Shinn Gulch Fed 5-31
 077-08190

WELL ABANDONMENT REPORT

API Number: 05-077-08190
Well Name: SHIRE GULCH FEDERAL Well Number: 5-31
Location (QtrQtr, Sec, Twp, Rng, Meridian): SWNW SEC. 31 T9S-R96W 6TH P.M.
County: MESA Federal, Indian or State Lease Number: _____
Field Name: SHIRE GULCH Field Number: 77450

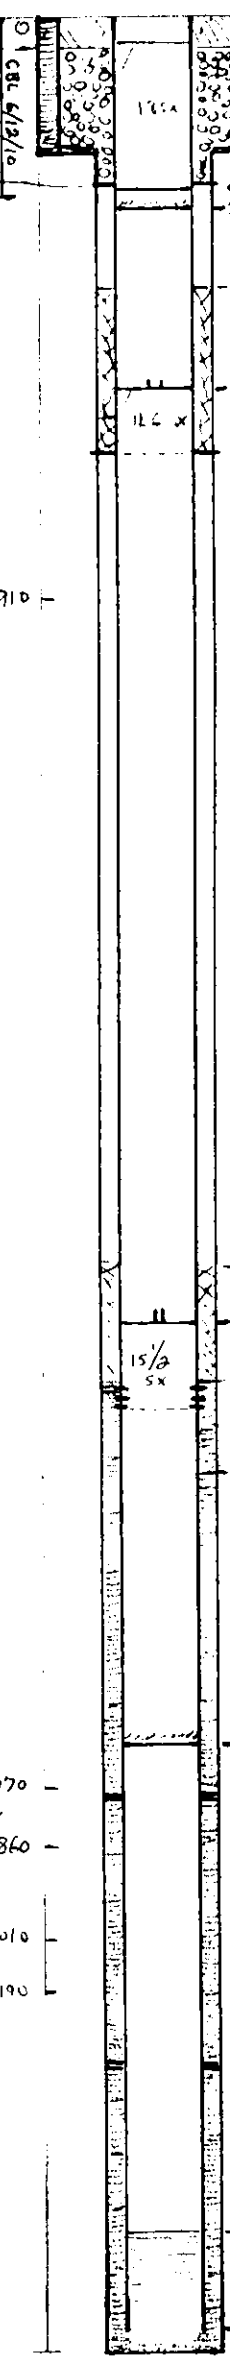
1.) TOC of 2136' from CBL Run 8/2/79 questionable.
Dual Ind /
Hence Later logs + Density/Neutron logs from 8/6/79
so well could not have been Cased

and ~~Chandler Assoc~~
No CBL mentioned on original 1979 Completion Rpt
Later logs + Density/Neutron are indicated

Please check - By calc I get toc of 2283 so 2136 may be calculated?

2.) Do you have Mess Unionia records for

● CIBP at 2700' ?
and
at 300' ?
